PLANNING BOARD MEETING AGENDA

Re: Wickes Arborists – 11 McNamara Road
Response to Site Plan and Special Permit Review comments

The following are in response to comments prepared by Brooker Engineering, PLLC dated May 23, 2023.

CONCRETE DROP CURB DETAIL

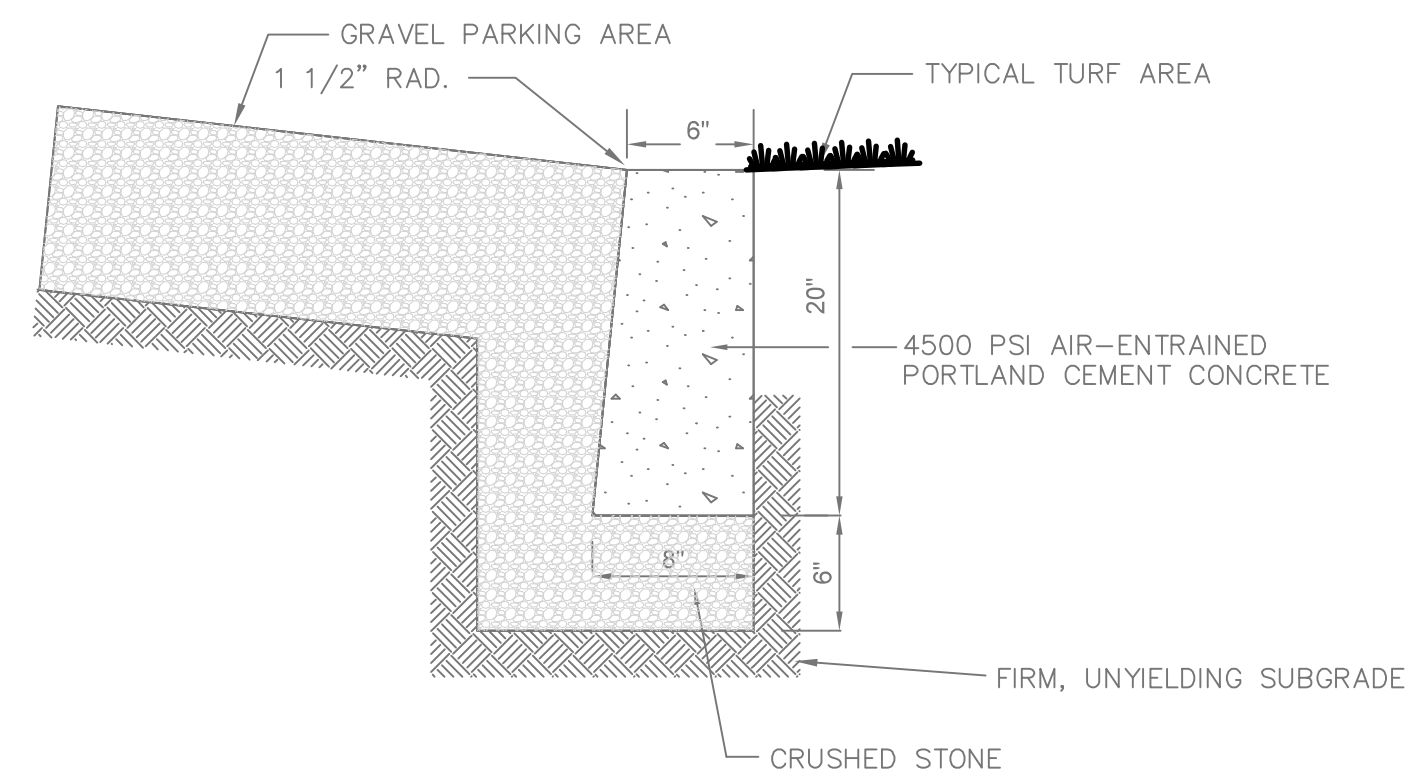
- 11. Additional drop curbs appear necessary to accommodate proposed configuration of catch basins/flo-gard prefilters. Outlet of catch basin to be clarified. Detail suggests a piped overflow is needed. Grading/inverts to be confirmed.**

Response: An additional Drop curbs and an additional flo-gard pre-filter have been proposed. The overflow has been designed to flow overland in a grass swale to McNamara Road drainage system. An underdrain is not required in the rain garden if the soil infiltration rate is not sufficient. If soil testing determines an underrating is required, we will design it before construction.

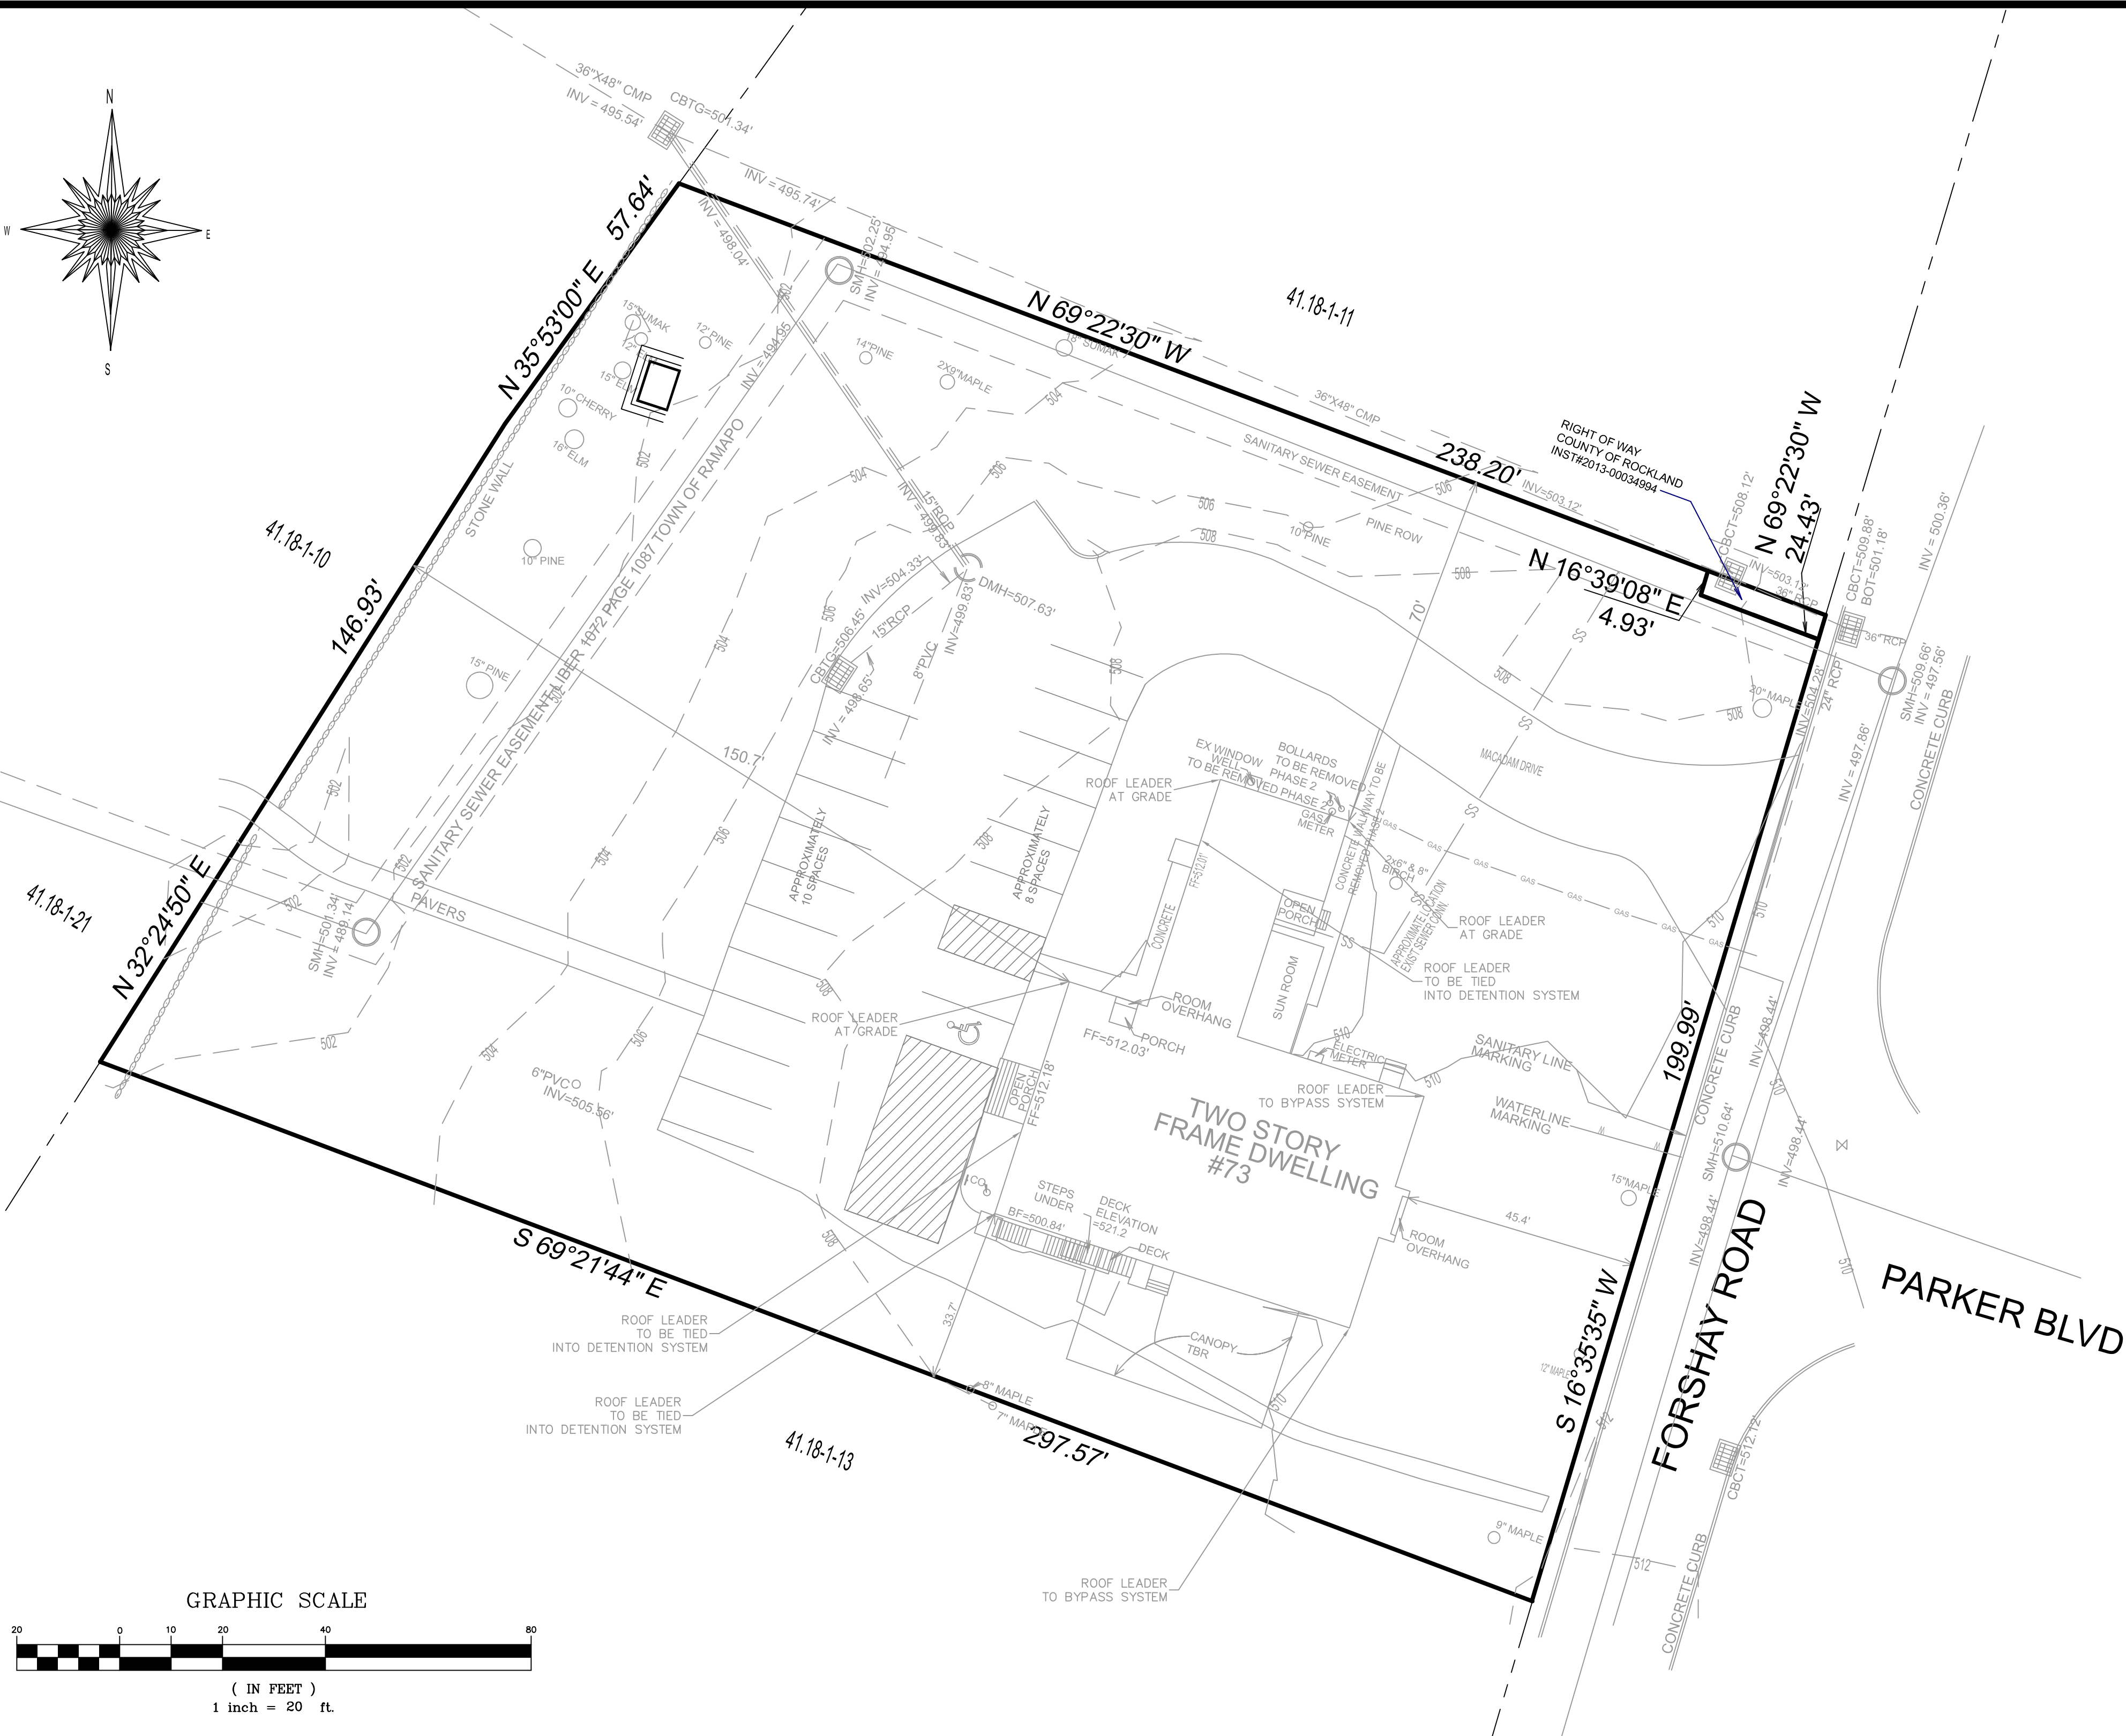
2. **It is unclear whether the proposed at-grade access walkway in front of the building will be constructed in Phase 1 or 2 as it is shown in both phases on Sheets 1 and 5. Please clarify exactly what items will be constructed in each phase.** The walkway is now only shown for phase 2.

6. **Please provide a Table of Dimensional Requirements Table for both sheets 1 and 5. Each table should have different values, corresponding to the construction proposed in each phase. For instance, each table for each phase should show different values for the maximum impervious surface ratio, to reflect changes between phase 1 and phase 2 of the project, when the building footprint will be increased. Separate bulk tables are now provided for phase 1 and phase 2.**

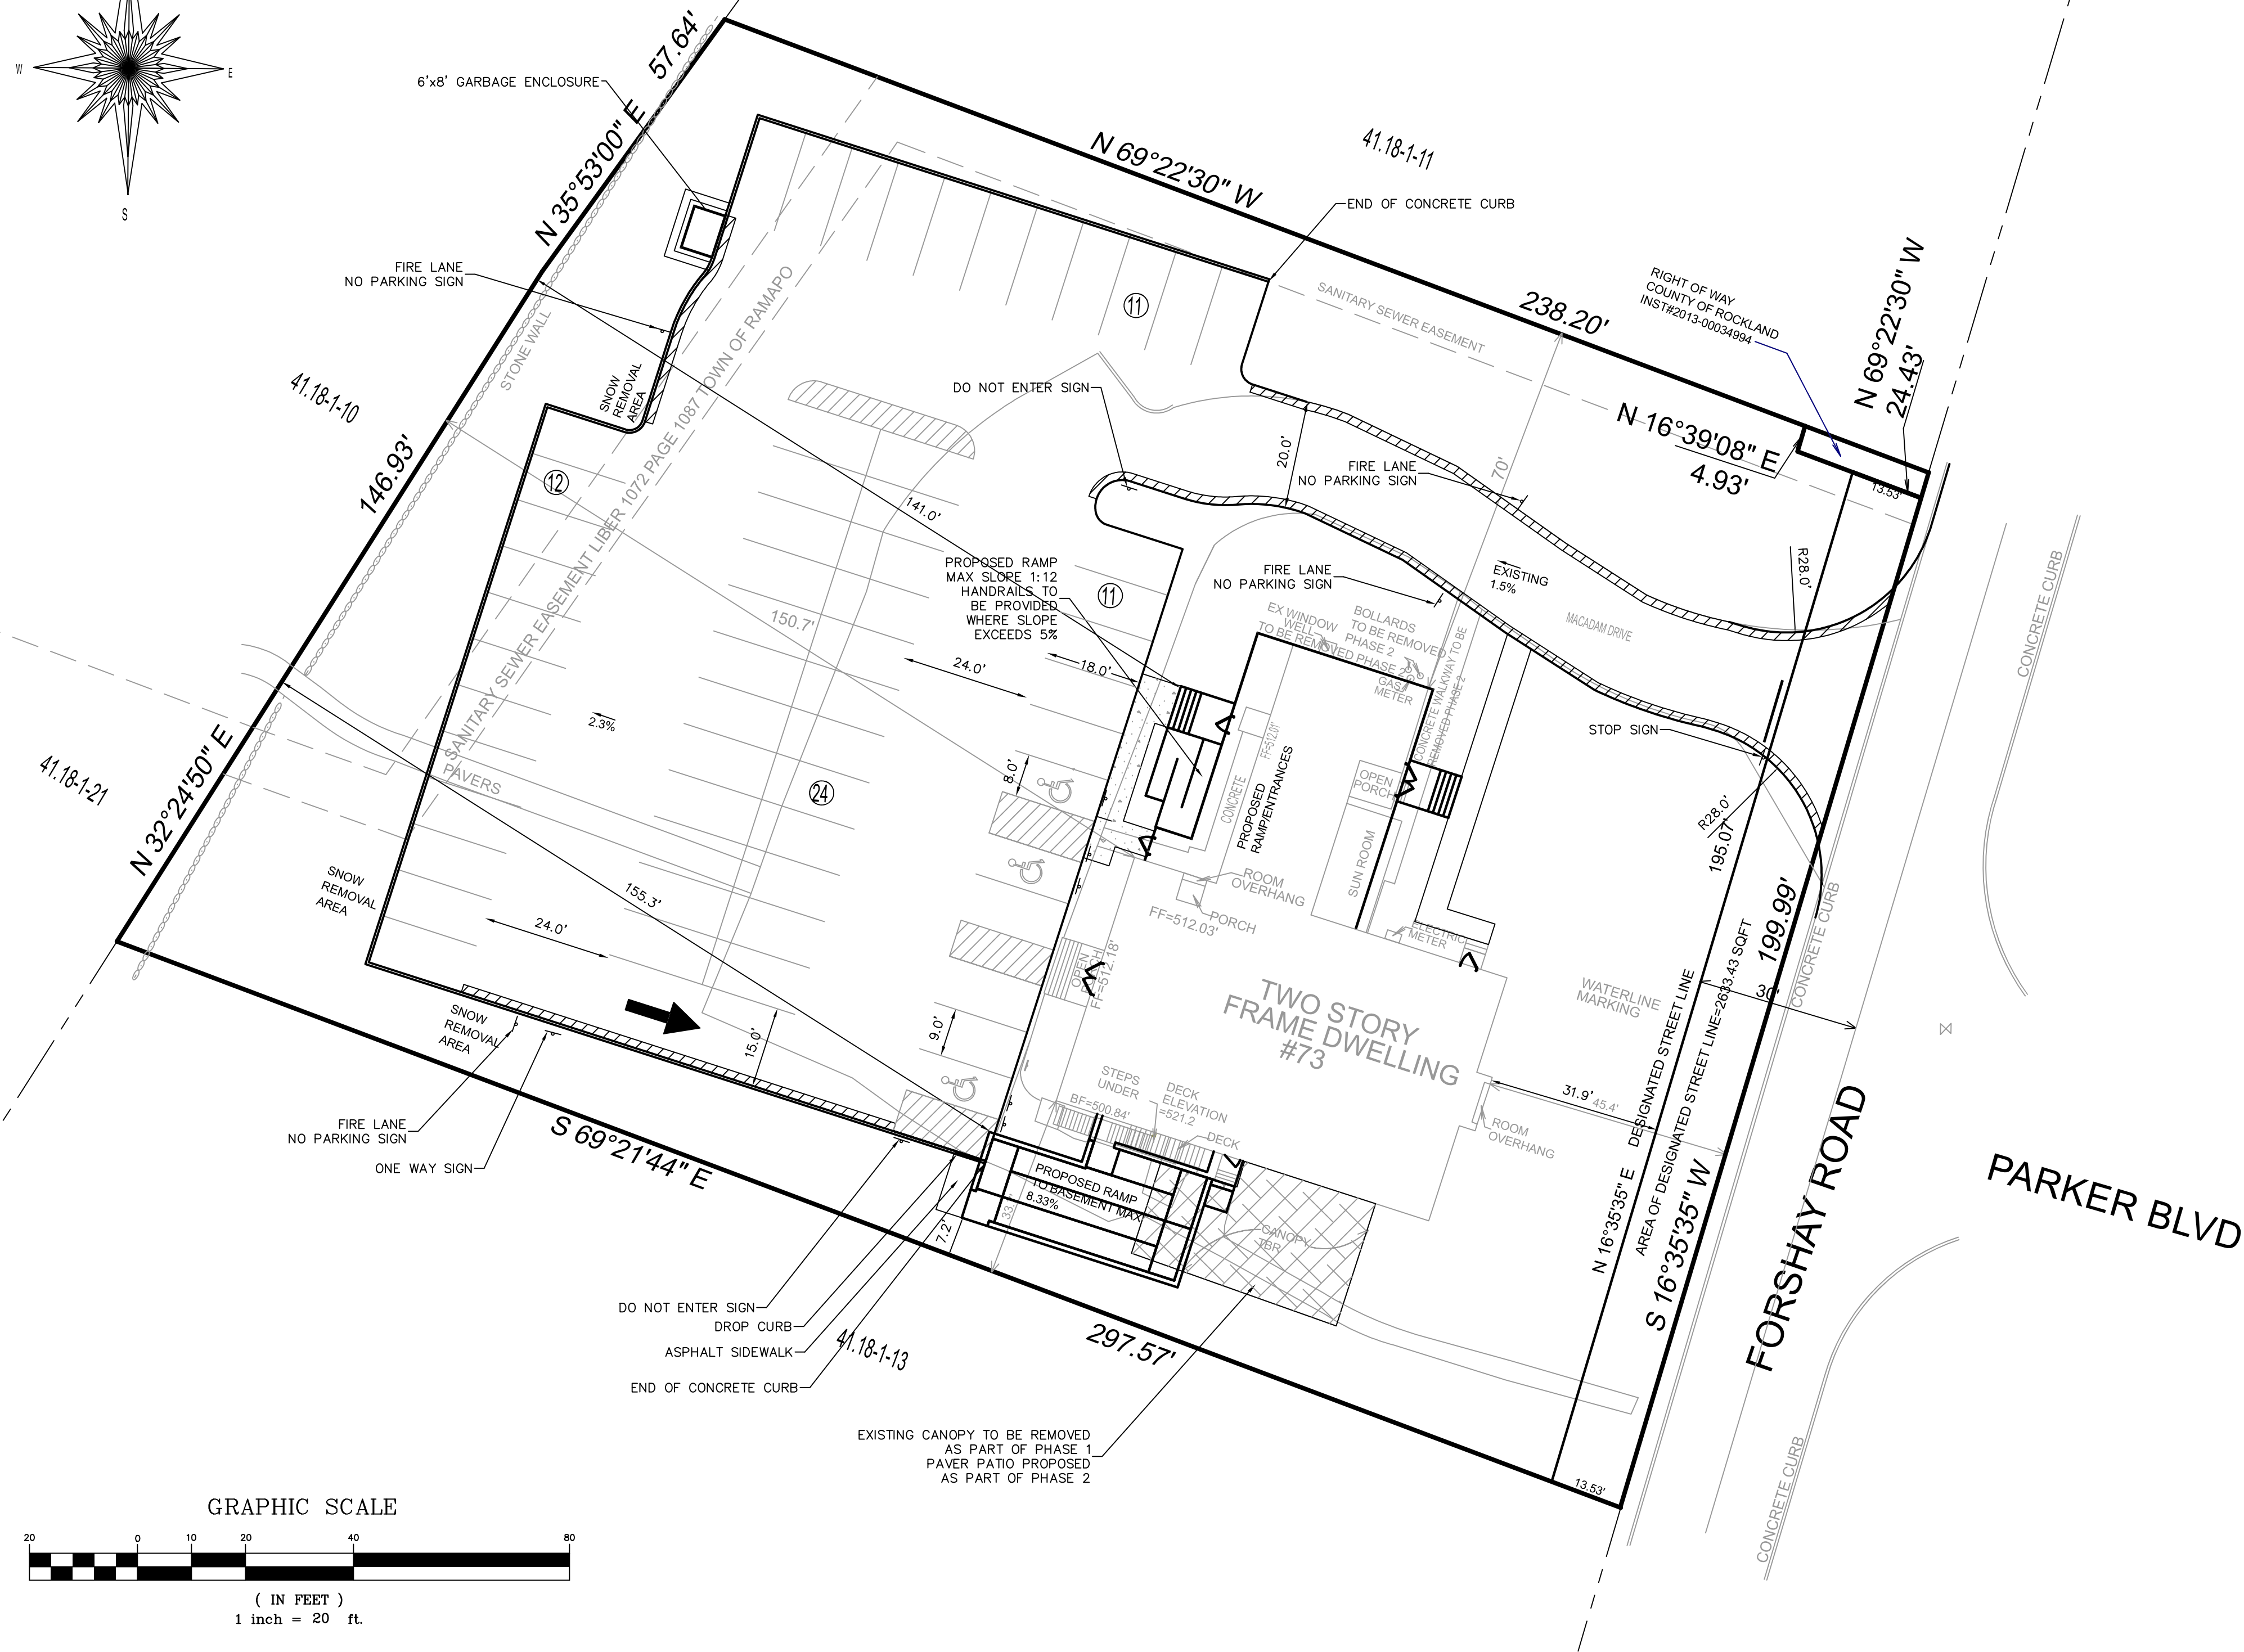
11. **To help reduce the impact of this development, a reduction of impervious surface should be considered. The amended Site Plan Phase 2 (Drawing 5 of 9) indicates that pervious pavers are proposed to be used for a patio at the southern side of the structure. It is recommended that porous pavers or porous concrete be considered to replace the use of conventional asphalt in additional areas of the site, as well. If installed correctly and properly maintained porous pavers have been shown to be effective in helping manage off-site runoff of stormwater. In addition to permeable pavers, other green infrastructure techniques should be considered such as bioswales, rain gardens, and rainwater capture. For long term effectiveness of permeable pavers and other green infrastructure techniques it is recommended that the Village and the applicant review Chapter 5 'Green Infrastructure Practices' of the 2015 NYSDEC Stormwater Design Manual. Based on the ground water, pervious pavers are no longer proposed.**

11 To help reduce the impact of this development, reduction of impervious surface should be considered. The Amended Site Plan Phase 2 (Drawing 5 of 9) indicates that pervious pavers are proposed to be used for a patio at the southern side of the structure. It is recommended that porous pavers or porous concrete be considered to replace the use of conventional asphalt in additional areas of the site, as well. If installed correctly and properly maintained porous pavers have been shown to be effective in helping manage off-site runoff of stormwater. In addition to permeable pavers, other green infrastructure techniques should be considered such as bioswales, rain gardens, and rainwater capture. For long term effectiveness of permeable pavers and other green infrastructure techniques it is recommended that the Village and the applicant review Chapter 5 'Green Infrastructure Practices' of the 2015 NYSDEC Stormwater Design Manual.
